RELATED CORRESPONDENCE

Subj: Texas Utilities Electric Company, et al.
(Comanche Peak Steam Electric Station,
Unit 1 & 2); Docket Nos. 50-445 and 50-446 OL

SUPPLEMENT TO APPLICANTS' SEPTEMBER 24, 1984
RESPONSE TO NRC QUESTIONS FROM MEETINGS
OF AUGUST 8-9 AND AUGUST 23, 1984

Figure 1

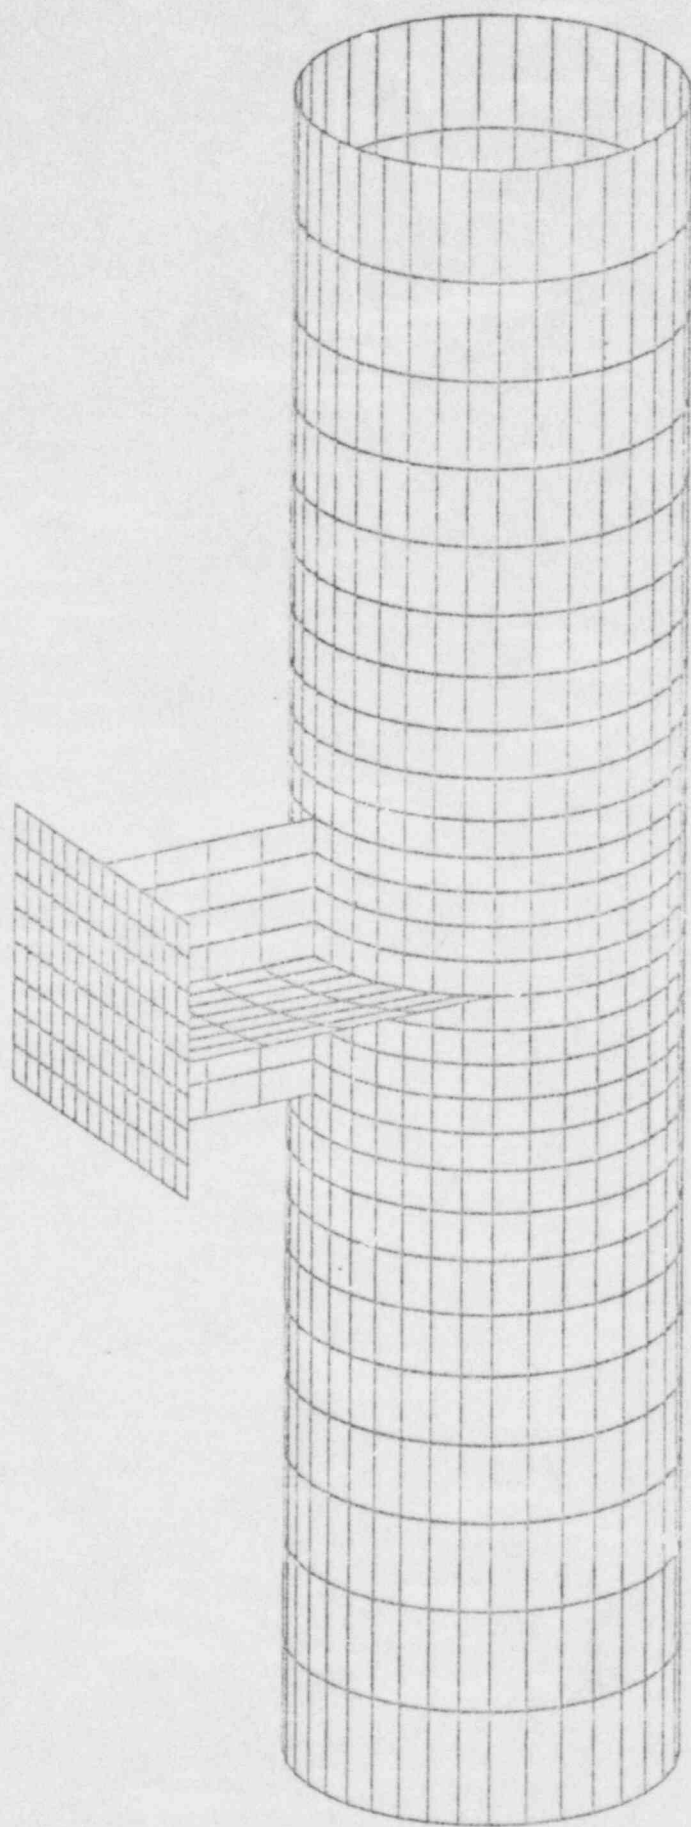
a) As we committed in our September 24, 1984, reply we have performed an evaluation of local stresses in the pipe at pipe support location FW-1-098-007-C62R. This analysis found those stresses to be within allowable stress limits.

Our evaluation was conducted by modelling the single cross-web trapeze attachment with a sufficiently long portion of complete pipe through the use of bending and stretching quadrilateral finite elements (see Figure 1). The model was then subjected to the appropriate transverse forces and torsional moments.

The largest stress computed from local effects only is 42.6 ksi of which 12.8 ksi represents the membrane portion of the stress, with the remainder being bending. These stresses were then combined with the general stresses from the piping analysis, as required in Attachment D8 of Gibbs & Hill Specification AB-2 titled "Integral Welded Attachment, ASME Code Class 2 and 3 Piping Verification Procedures". Actual values of S_c and S_h were computed from the certified mill test report for the SA333, Grade 6 material used in the piping fabrication. The minimum yield strength of the material certified in that report is 44.6 ksi and the minimum ultimate strength is 67.9 ksi.
